Steering Committee Meeting
April 23, 2021 3pm-4pm
ZOOM

Meeting Objective: Review San Bruno Avenue Master Plan Draft Diagrams with the San Bruno Avenue neighbors for input, noting that this is mostly about parking, sidewalks and curbs. Landscape solutions come later.

Concept Diagram Draft
Potrero Loop Phase II: San Bruno Master Plan
Option #1
SFPW- Landscape Architecture
Draft 4/21/2021

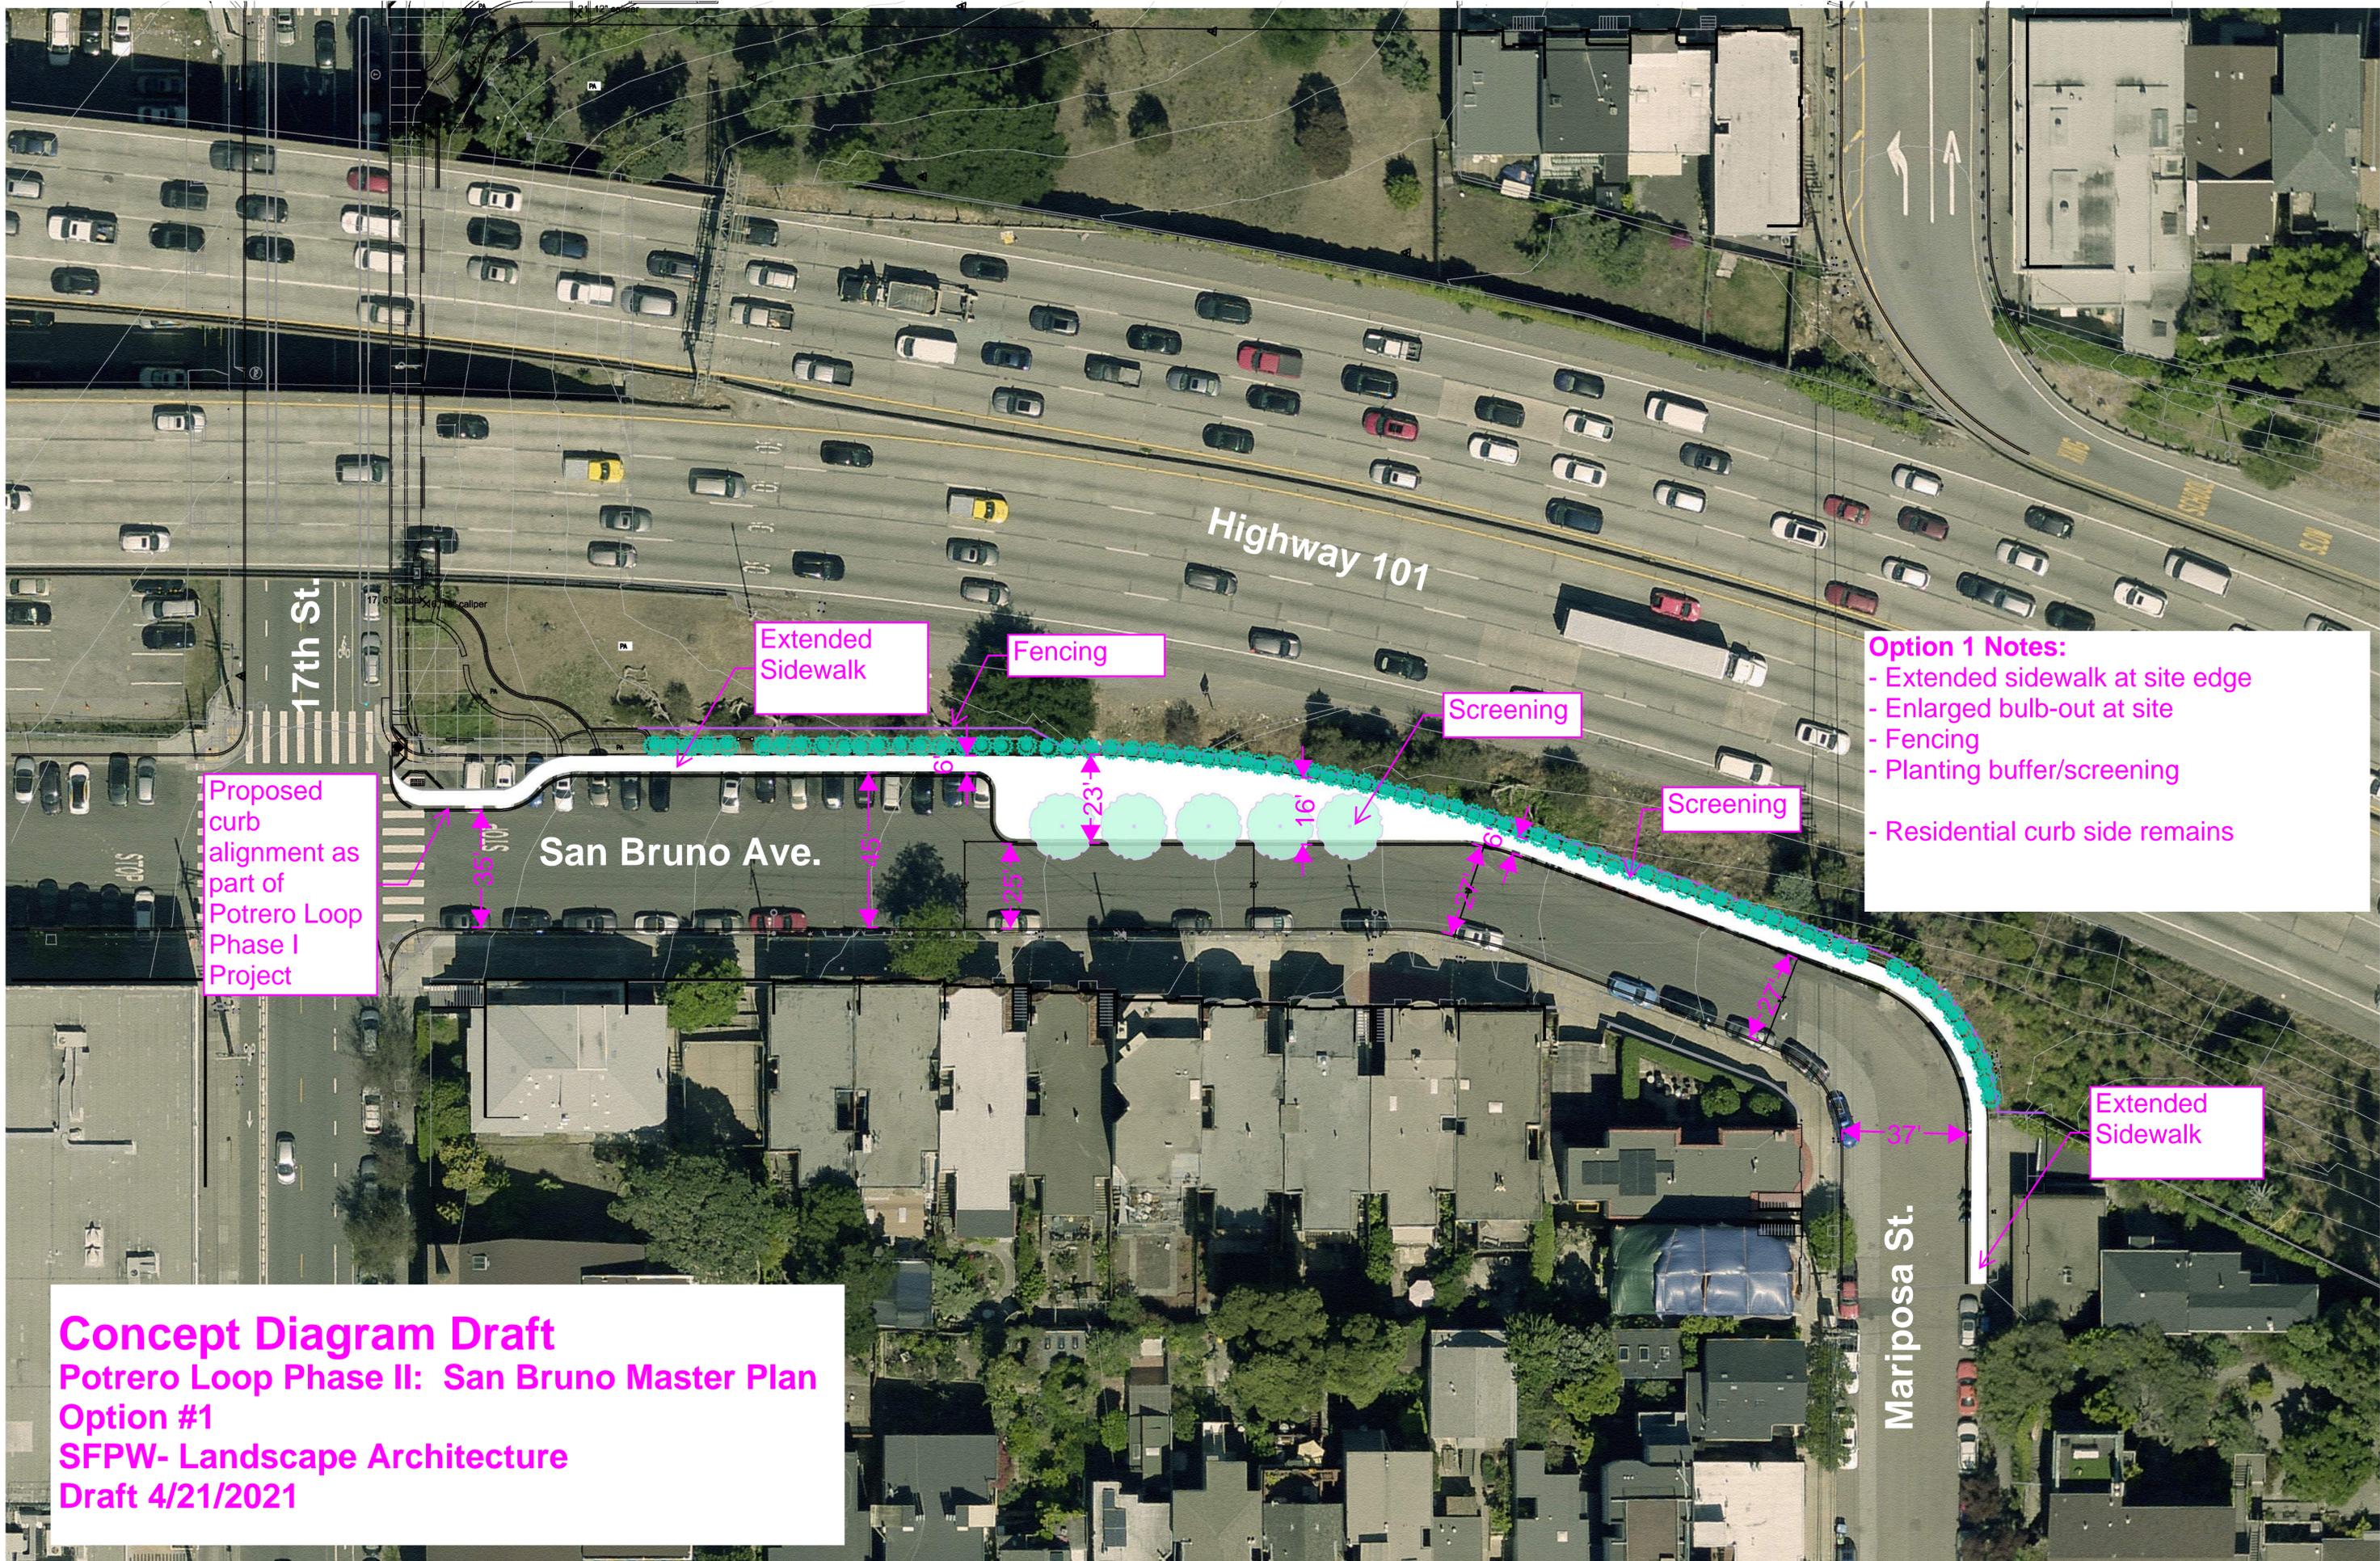
The meeting started at 3:04 with Concept Diagram Draft Option 1. Jasmine explained that the Phase 1 bulbout would need to be a little bigger to meet with the existing sidewalk for accessibility reasons. The existing sidewalk is about 3-4 ft and would be increased to 6ft. Option 1 added a sidewalk/plaza area at the south end of the perpendicular parking. There were questions about the size of the road at both ends of the sidewalk/plaza. Why lose 2 feet at the north end? Is visibility bad driving north for the car near the plaza when backing out?

The drawing shows no parallel parking on the east side of San Bruno. Removing parallel parking at the corner is an idea the neighborhood likes. They did not get a majority for the 2-hr. parking mostly because of the cost. Some neighbors have more than one car.

- Adding the white strip for accessibility to the phase 1 bulbout was fine.
- The mid-block screening has potential, but concern about camping needs to be addressed. Don't remove it.
- If the neighbors want street trees on the west side, that would be good screening.
- Removing parallel parking on the east side would be good but need to determine how much.
- Keep or extend the perpendicular parking on the east side.

Concept Diagram Draft
Potrero Loop Phase II: San Bruno Master Plan
Option #2
SFPW- Landscape Architecture
Draft 4/21/2021

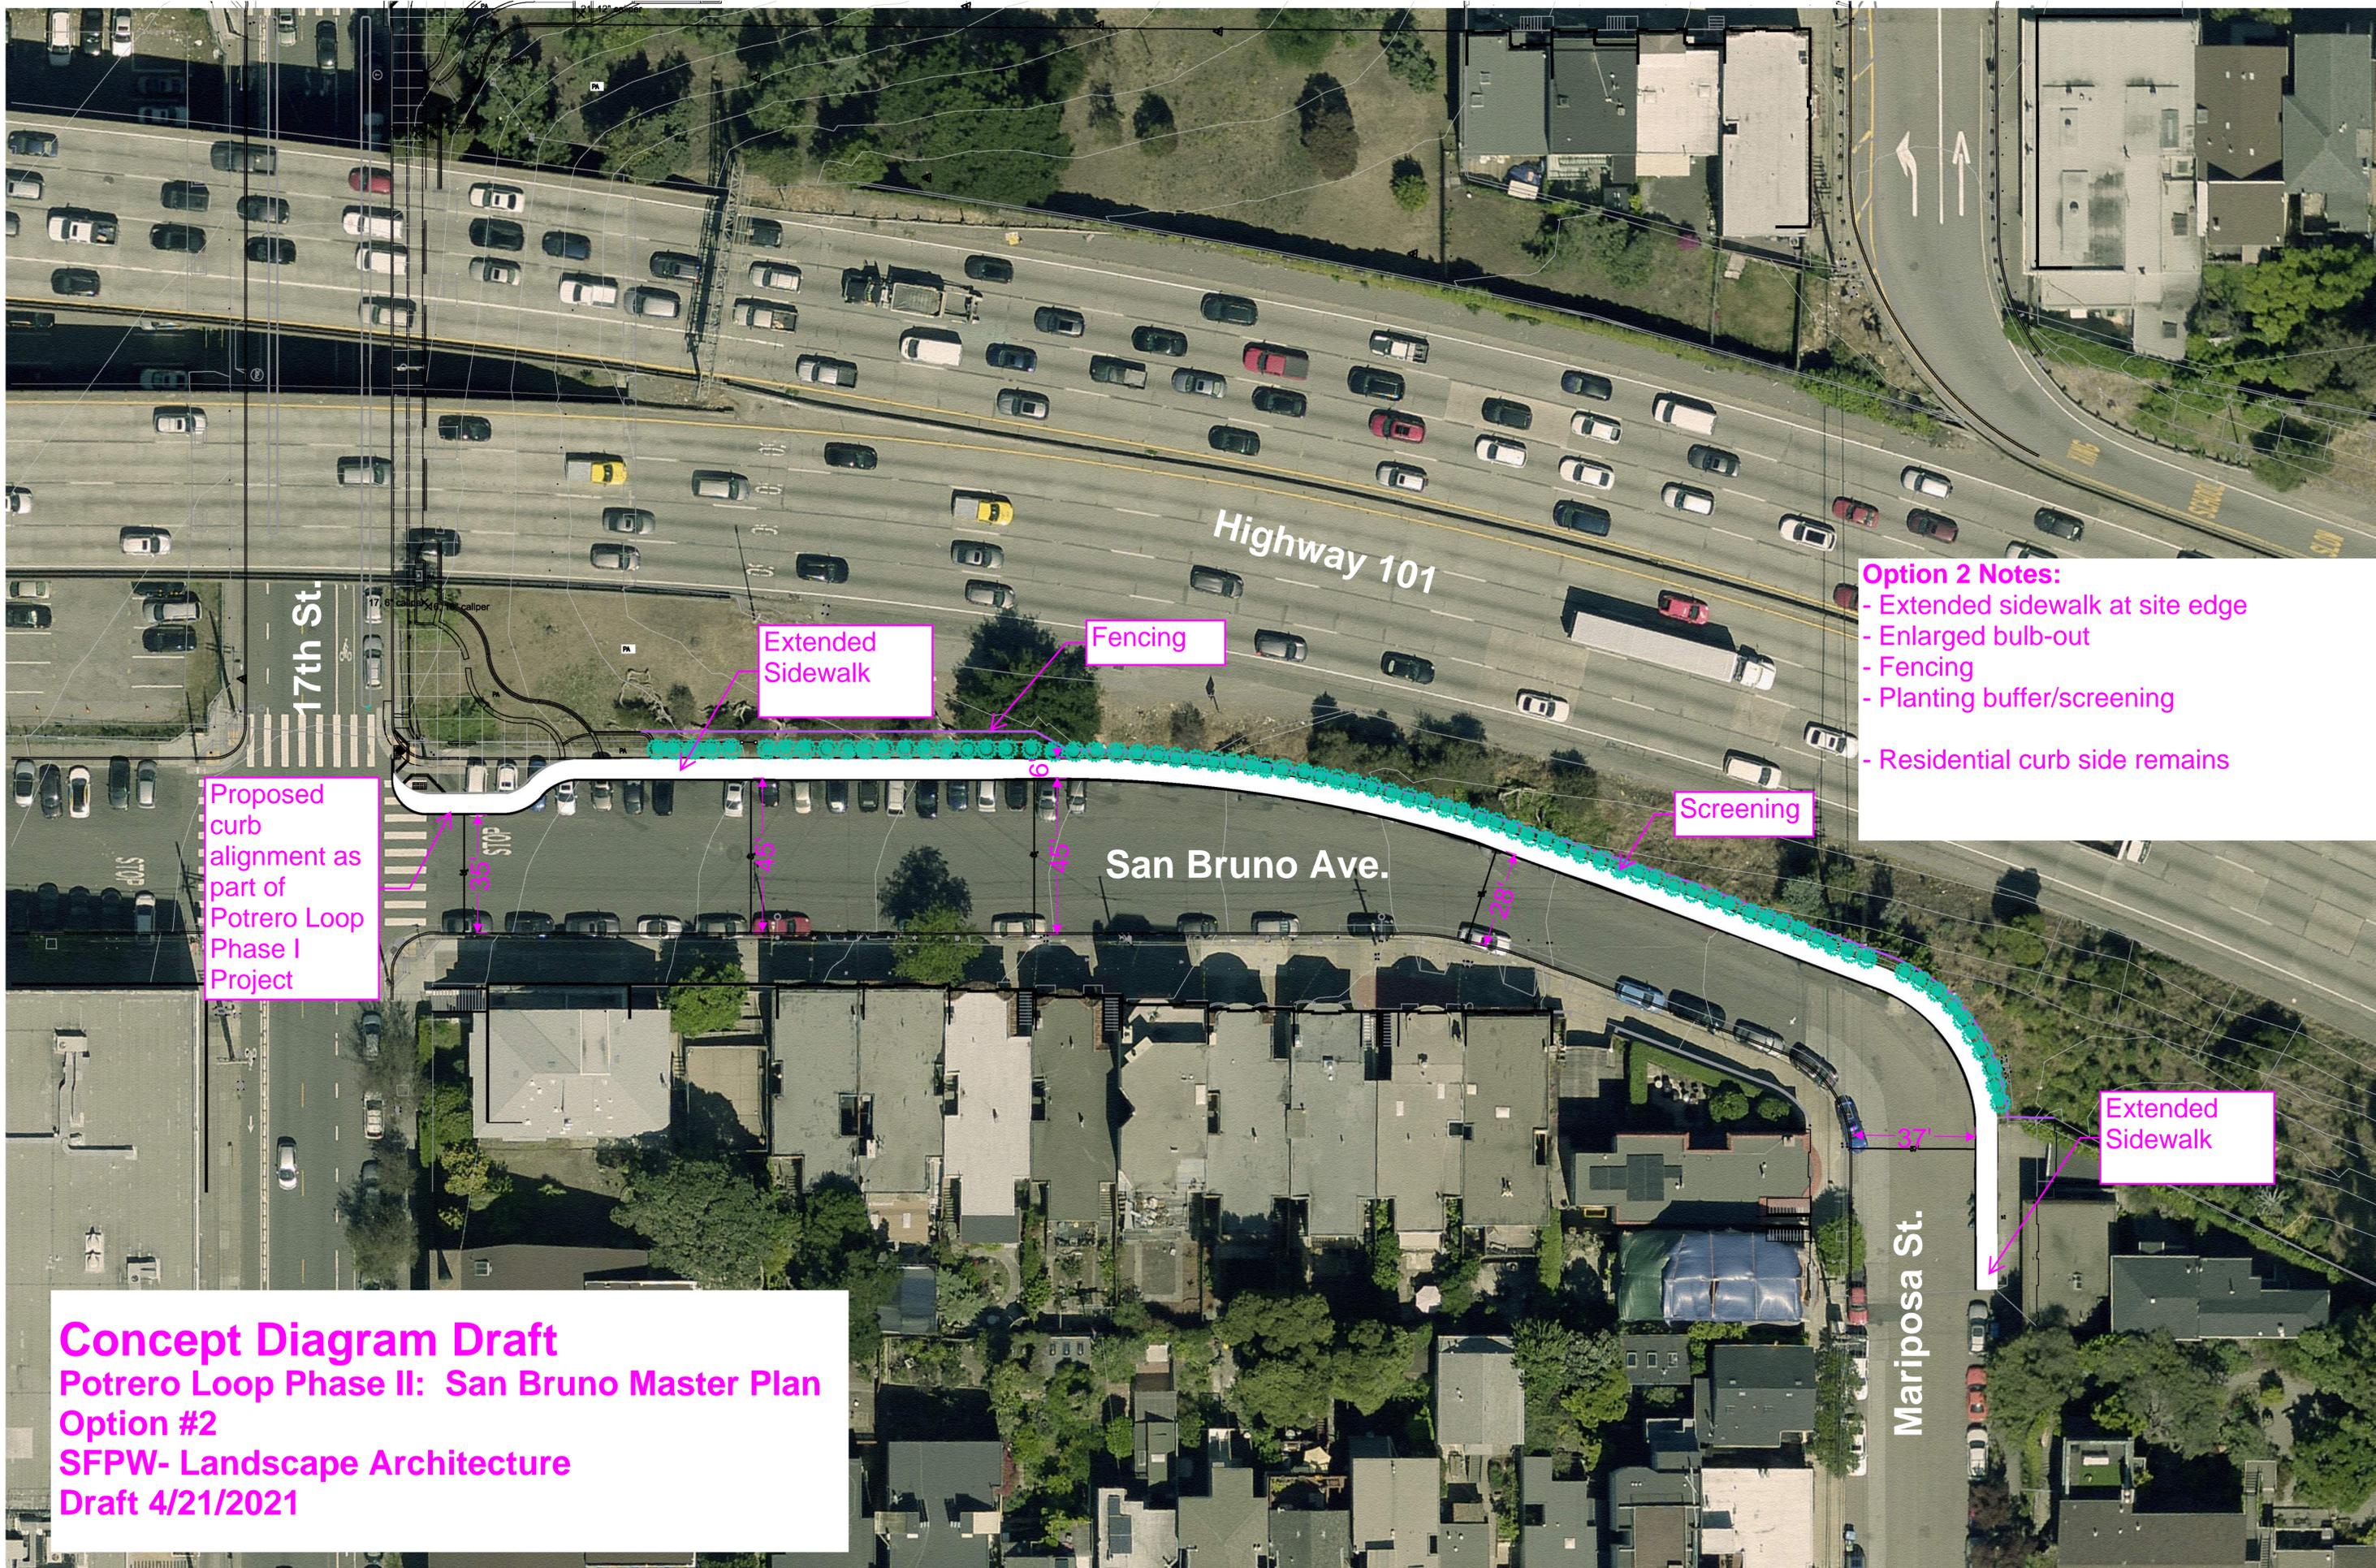
Option 2, which is the simplest, also included the removal of parallel parking on the east side and was received positively.
